**Design Exceptions
(Contract Document)**

**Innerbelt Bridge
Construction Contract Group 1 (CCG1)**

Subject: Cleveland Innerbelt Project
CUY – 71/90 – 16.79/14.90, PID: 77510
Design Exceptions CCG1

INFORMATION FOR EXCEPTION TO THE MINIMUM DESIGN STANDARDS

CONTRACT GROUP 1 - ONTARIO STREET ON-RAMP TO WB I-90 DESIGN EXCEPTION

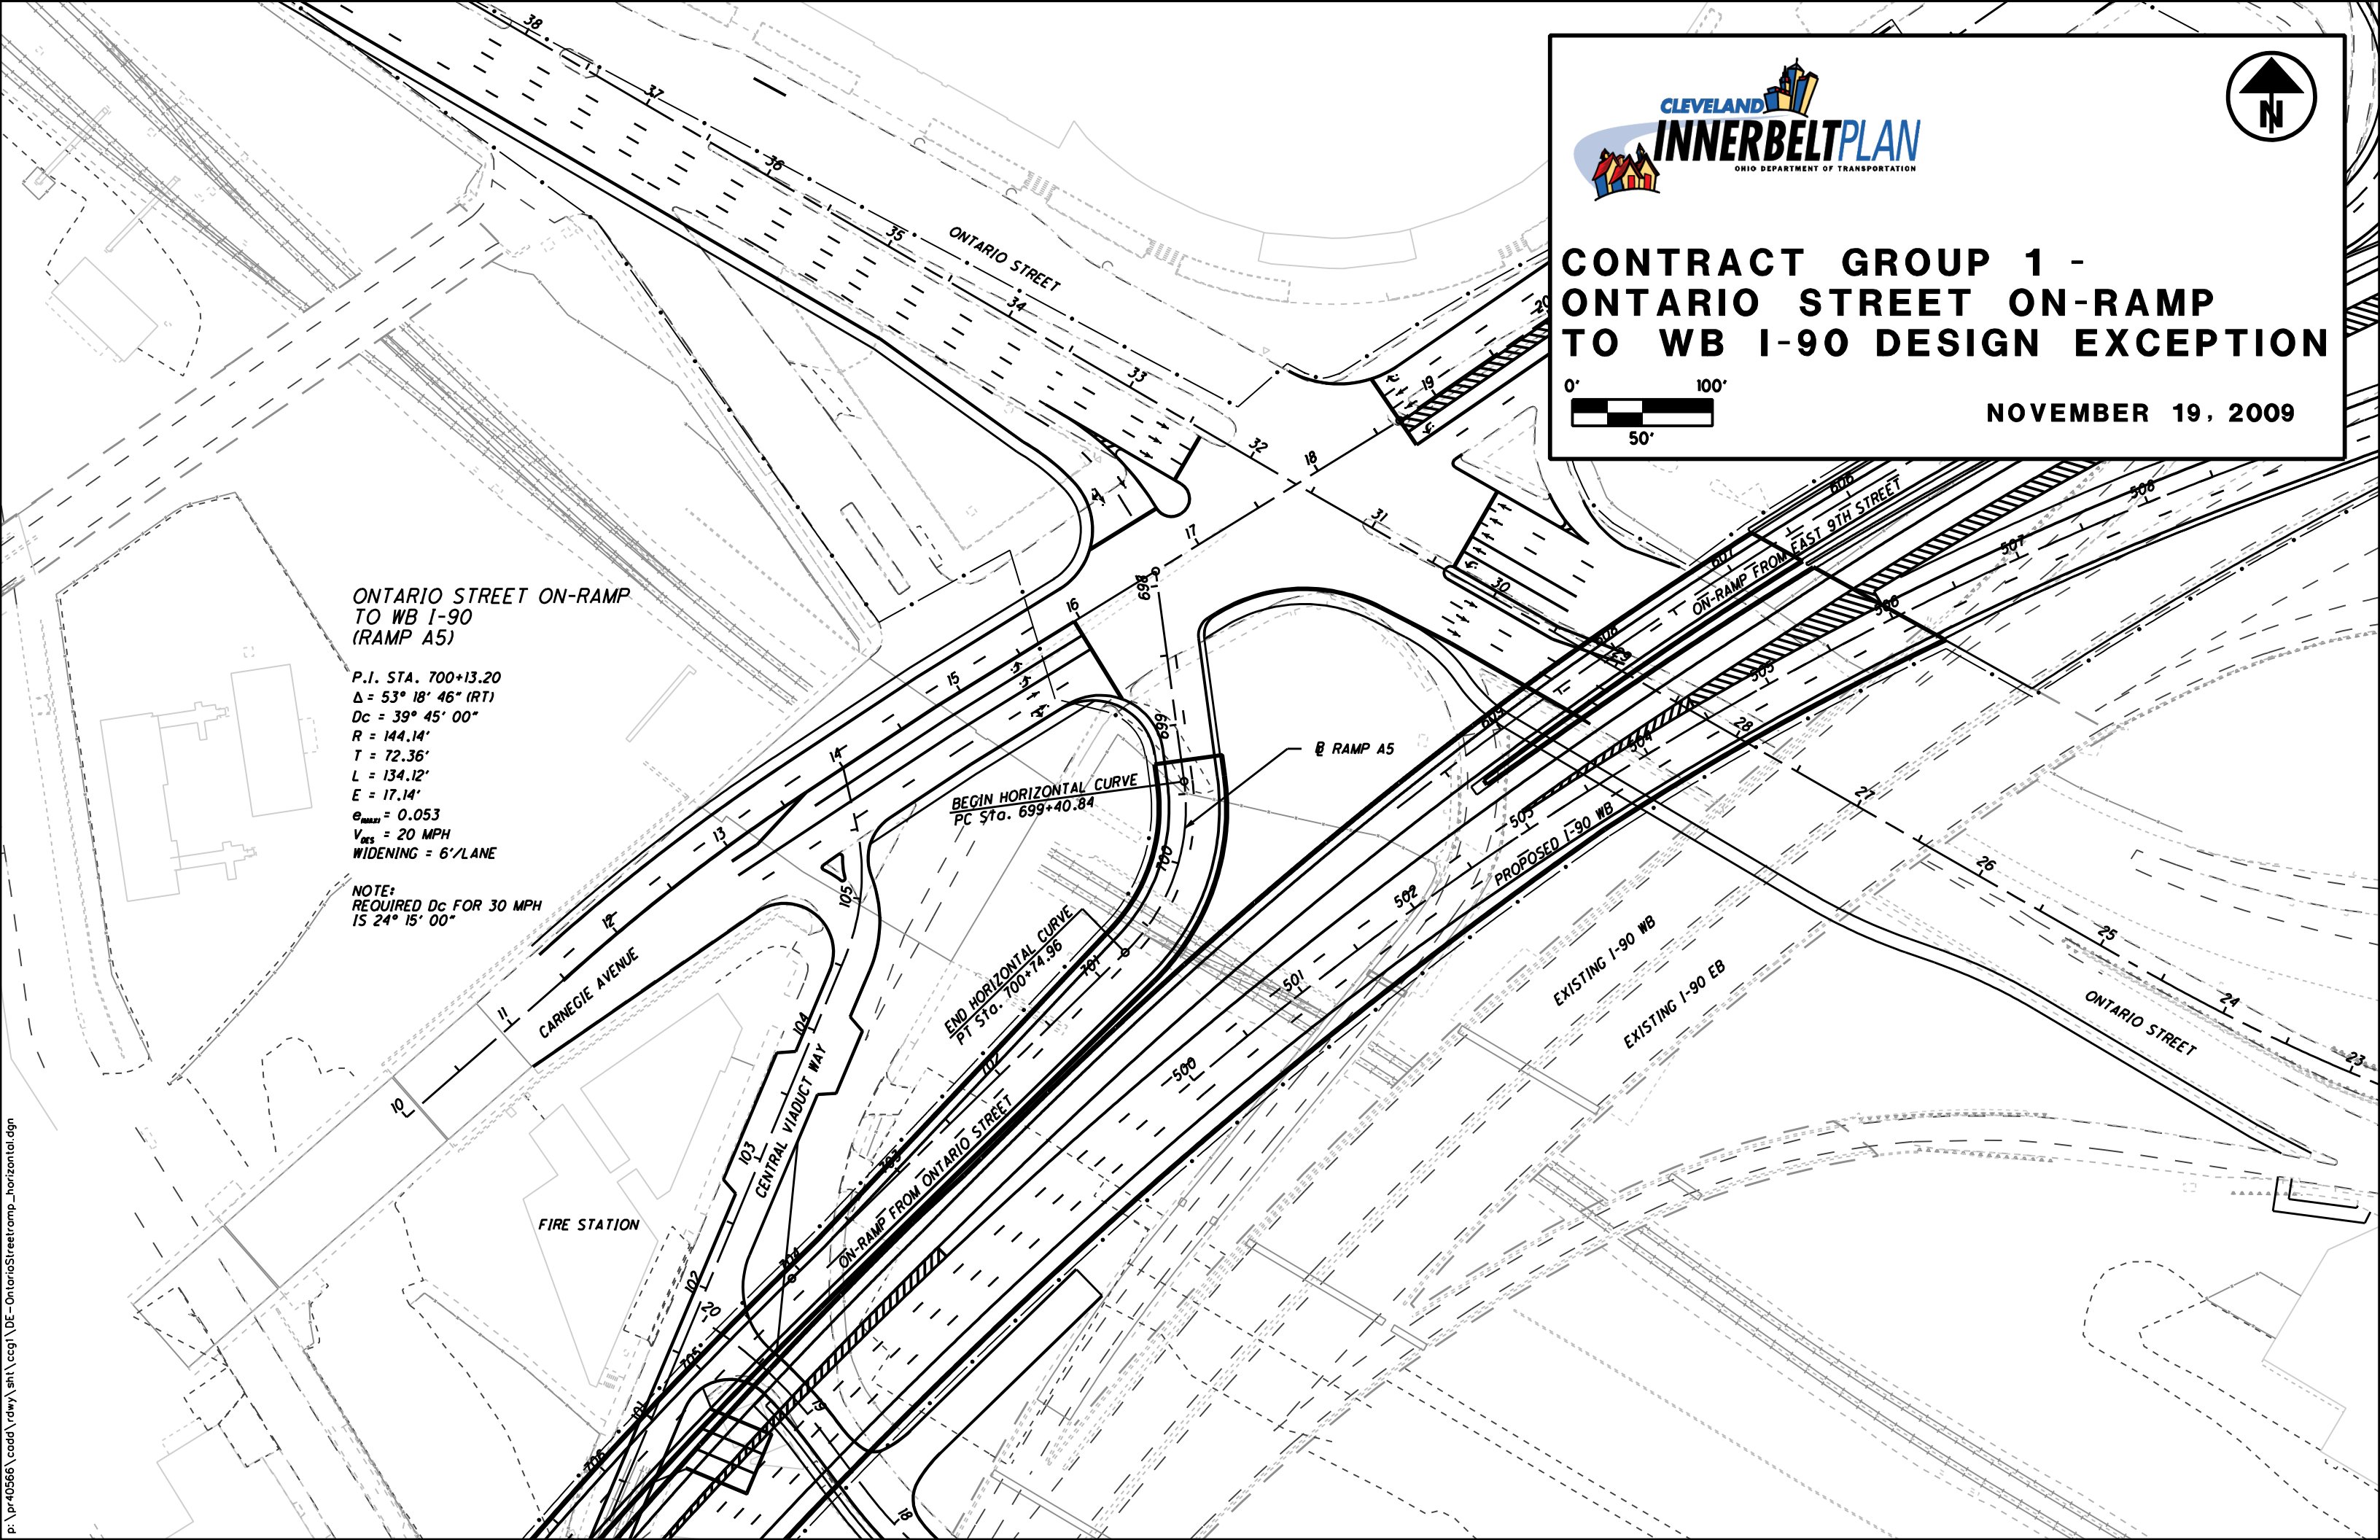
I-90 across the new WB Central Viaduct Bridge has a projected (2035) ADT of 71,000 vehicles per day with 6% truck traffic and a legal speed of 55 mph. The proposed Ontario Street on-ramp to WB I-90 (see Contract Group 1 – Ontario Street On-ramp to WB I-90 Design Exception) has a projected (2035) ADT of 9,900 vehicles per day. Proposed WB I-90 in the vicinity of the Ontario Street on-ramp will carry four twelve foot lanes. The dual lane Ontario Street on-ramp will taper to a single lane and then enter as an add lane forming the fifth twelve foot lane across the new WB Central Viaduct Bridge. Twelve foot inside and outside shoulders will be provided on the mainline, while on the ramp a 6 ft. right shoulder and 3 ft. left shoulder (4 ft. when barrier is present) is provided.

P.I. STA. 700+13.20
 $\Delta = 53^\circ 18' 46''$ (RT)
 $D_c = 39^\circ 45' 00''$
 $R = 144.14'$
 $T = 72.36'$
 $L = 134.12'$
 $E = 17.14'$
 $e_{max} = 0.053$
 $V_{DES} = 20$ MPH
WIDENING = 6'/LANE

NOTE:
REQUIRED D_c FOR 30 MPH
IS $24^\circ 15' 00''$

P.I. STA. 601+41.45
Δ = 89° 30' 25" (RT)
Dc = 49° 23' 34"
R = 116.00'
T = 115.01'
L = 181.21'
E = 47.35°
e_{max} = 0.057
V_{DES} = 20 MPH
WIDENING = 6' / LANE

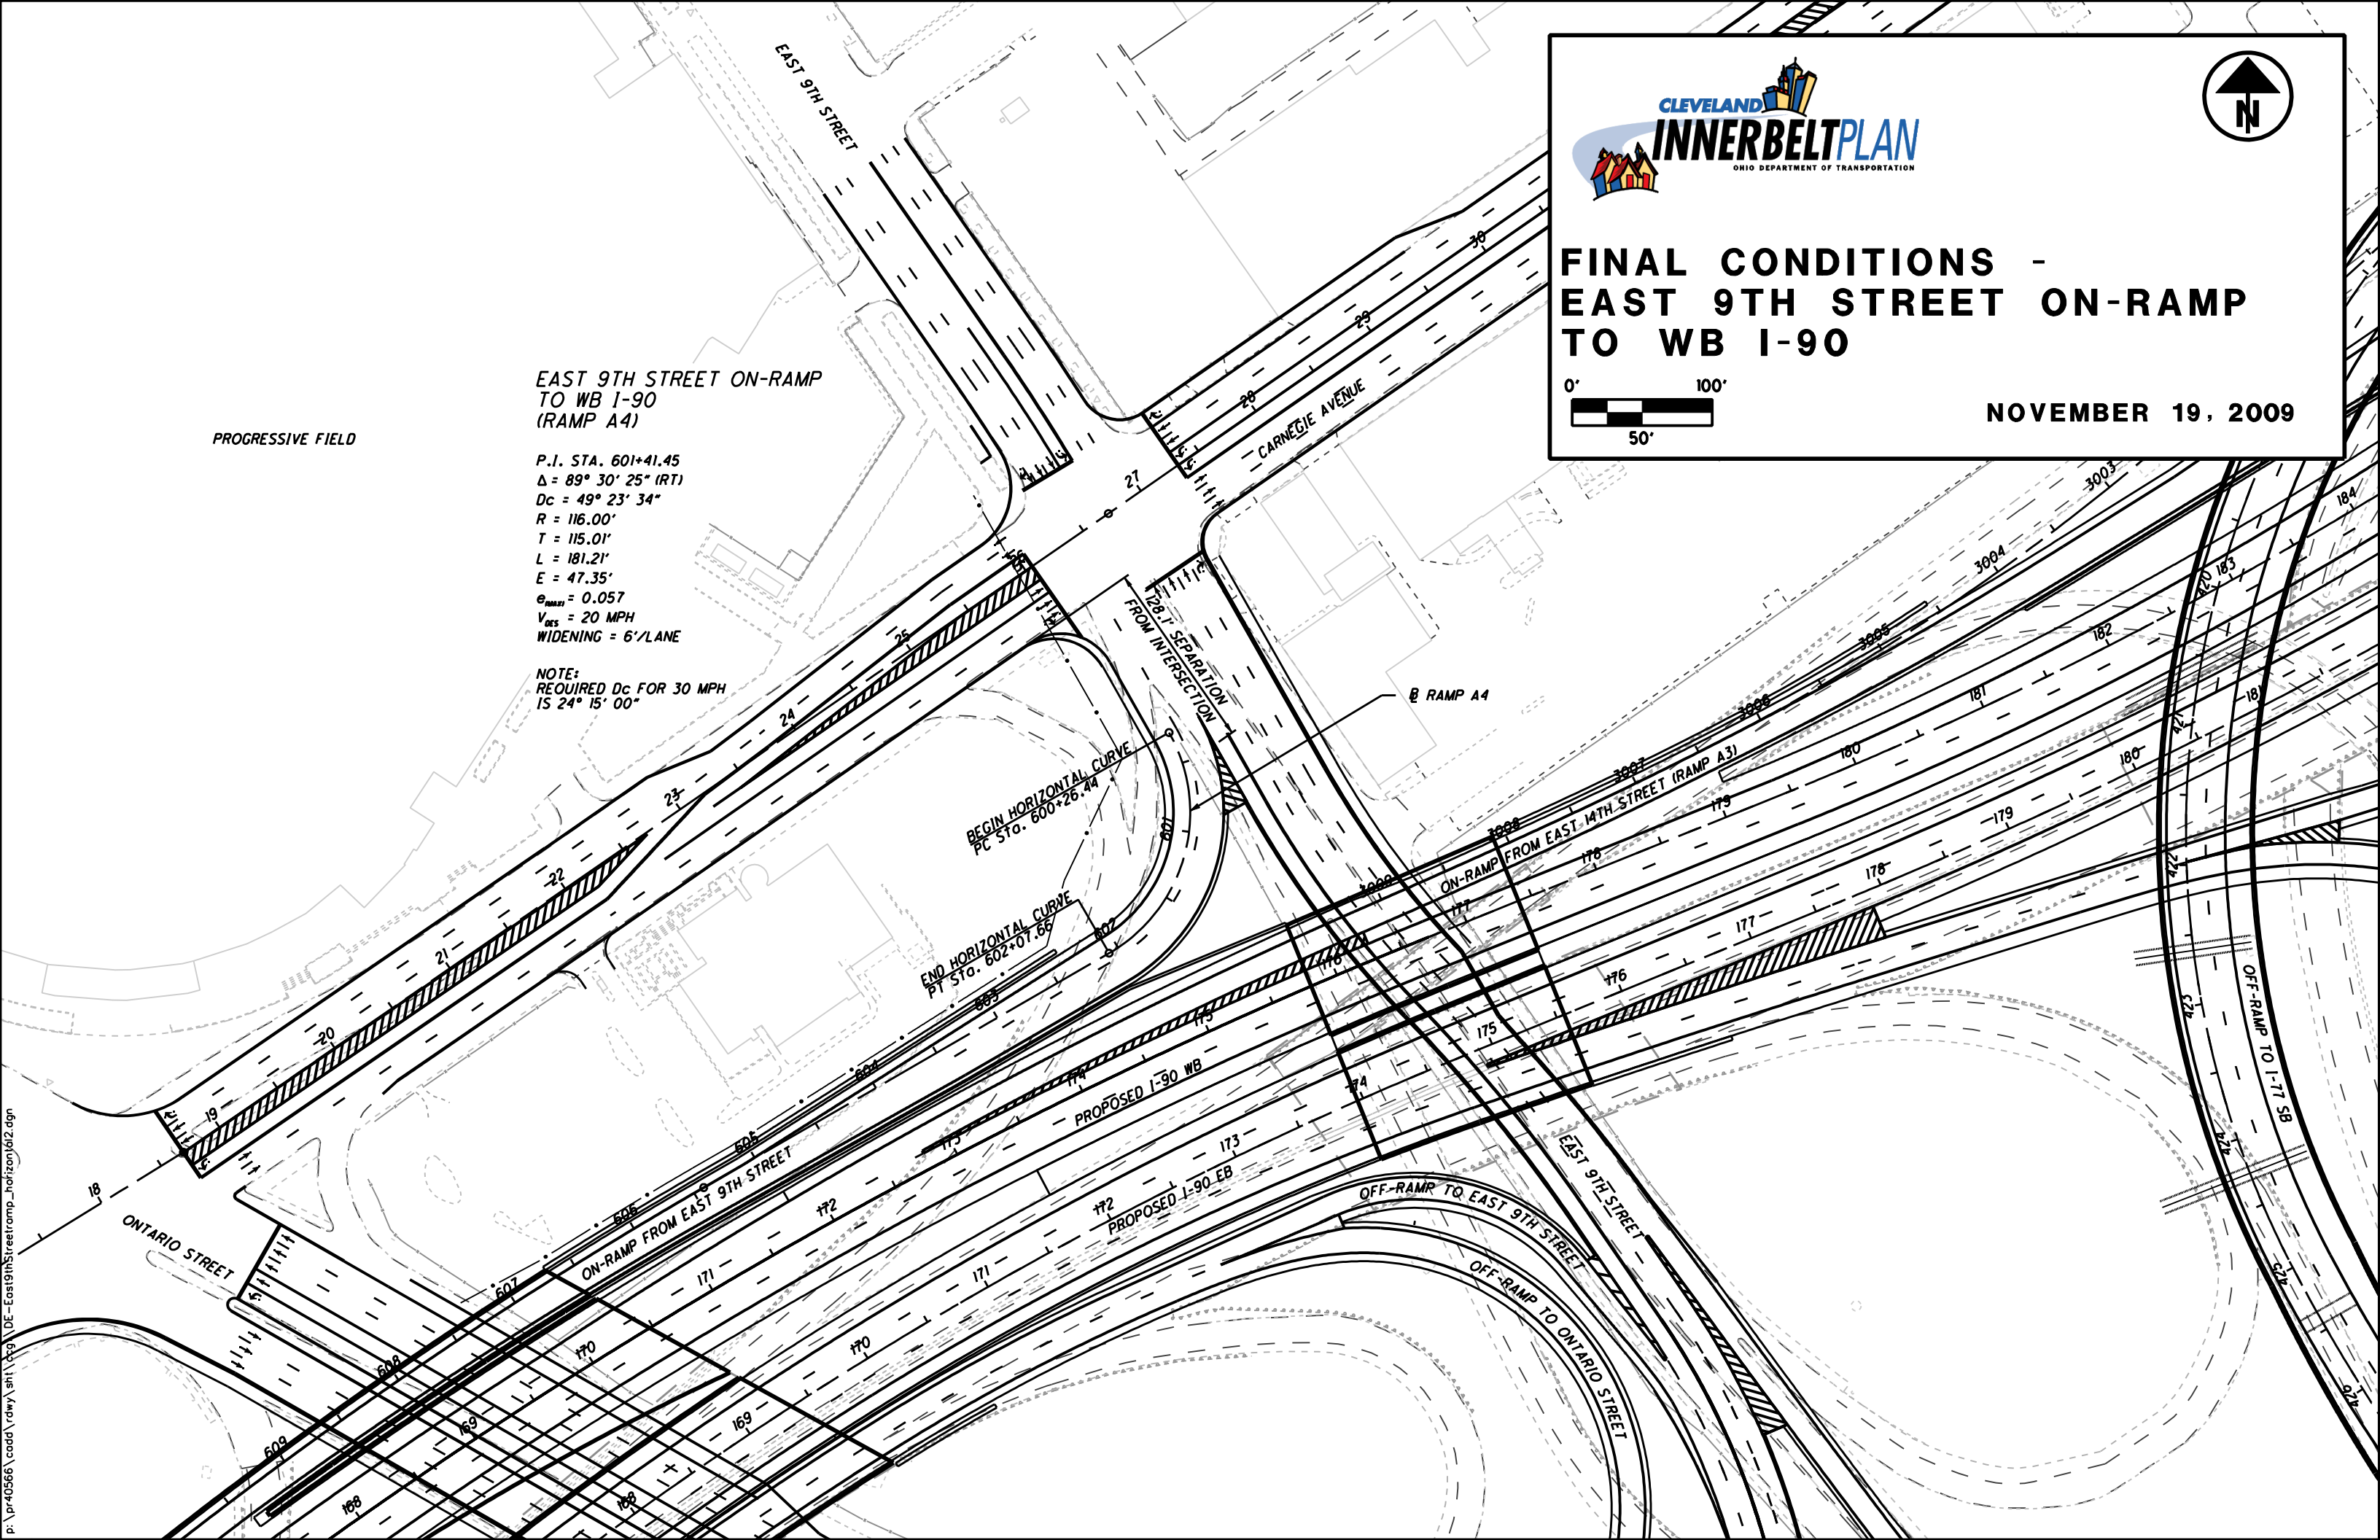
I-90 across the new WB Central Viaduct Bridge has a projected (2035) ADT of 71,000 vehicles per day with 6% truck traffic and a legal speed of 55 mph. The proposed East 9th Street on-ramp to WB I-90 (see Contract Group 1 – East 9th Street On-ramp to WB I-90 Design Exception) has a projected (2035) ADT of 7,000 vehicles per day. Proposed WB I-90 in the vicinity of the East 9th Street on-ramp will carry four twelve foot lanes. The dual lane East 9th Street ramp will taper to a single lane and enter WB I-90 as a merge lane, then the Ontario Street on-ramp will enter as an add lane forming the fifth twelve foot lane across the Central Viaduct Bridge. Twelve foot inside and outside shoulders will be provided on the mainline, while on the ramp a 6 ft. right shoulder and 3 ft. left shoulder (4 ft. when barrier is present) is provided.

NOTE:
REQUIRED Dc FOR 30 MPH
IS 24° 15' 00"

**EAST 9TH STREET ON-RAMP TO WB I-90
 (RAMP A4)**

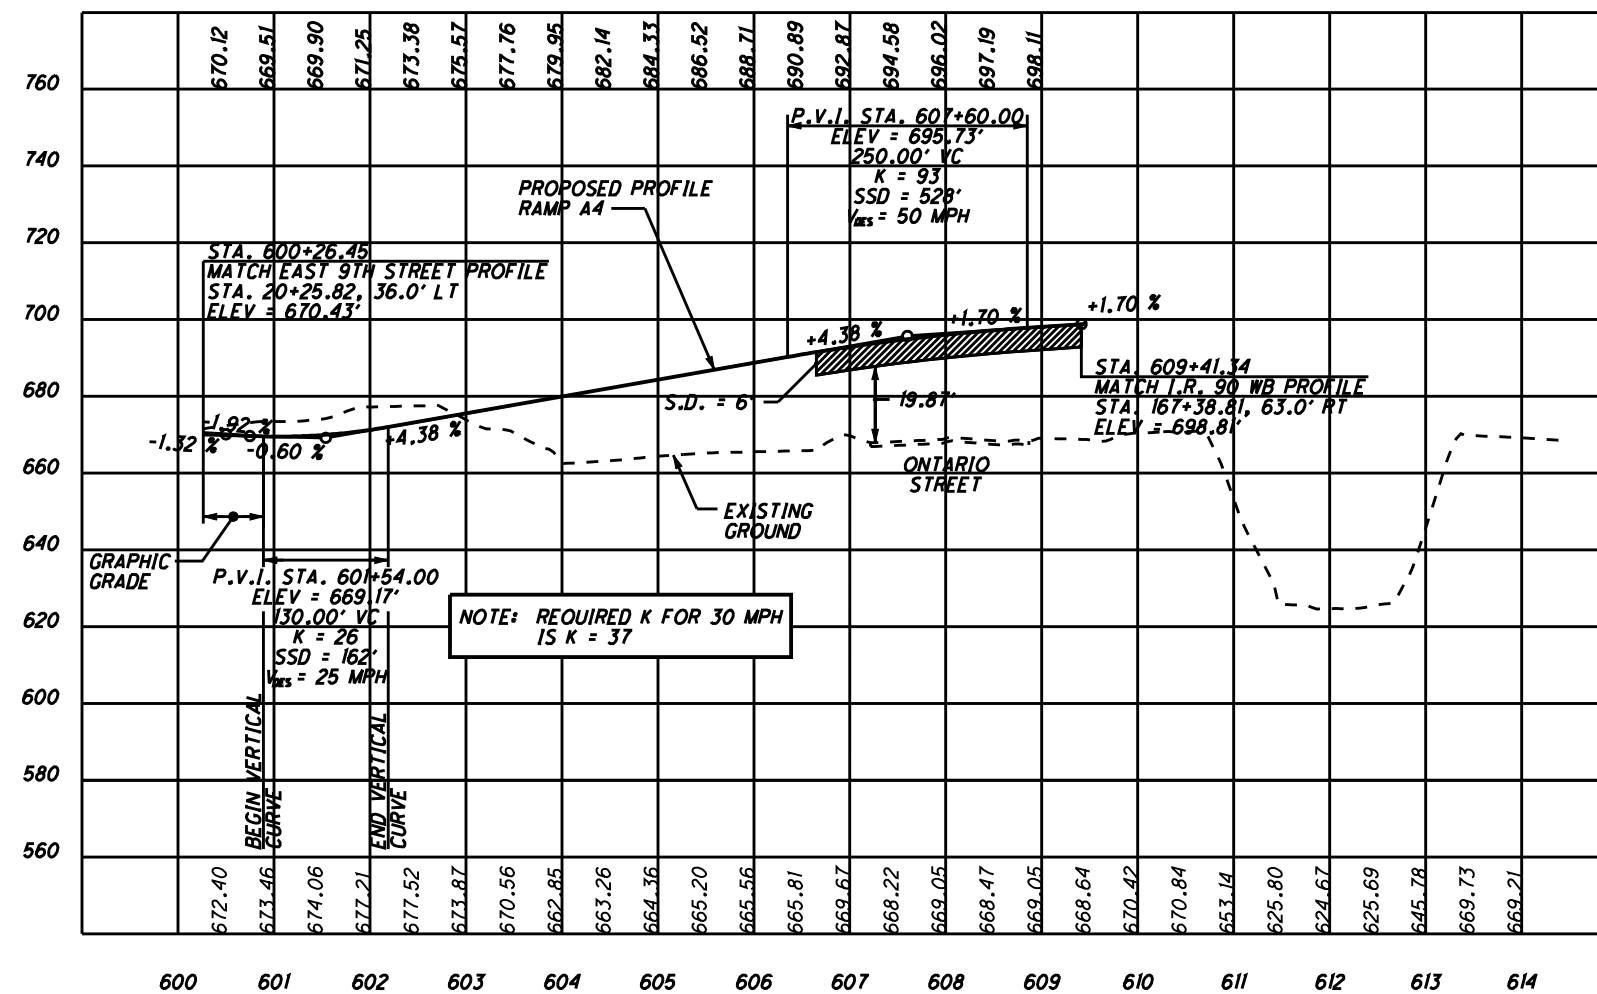
The second approach considered looked at what it would take to meet the 30 mph design requirements for the initial horizontal and vertical curve that begins the geometry of this ramp. By reconfiguring the ramp to provide a 30 mph curve design, without impacting the mainline I-90 alignment, the 100 ft. minimum separation from the intersection cannot be maintained. This would not require a design exception. Under this approach, the ramp essentially becomes another leg of the intersection of East 9th Street and Carnegie Avenue, but cannot be adequately separated from the SB East 9th Street leg of the intersection enough to provide a clear visual cues to drivers. In addition, it would not be possible for this design approach to meet required superelevation position as outlined in Section 202.4.6 Superelevation Position in ODOT's *Location and Design Manual Volume 1*. Based on this guidance, a design exception is required if the following is not provided: "the transition shall be placed so that 50 percent to 70 percent of the maximum superelevation rate is outside the curve limits (PC, PT)." As such, a design exception would be required for superelevation to account for this deviation.
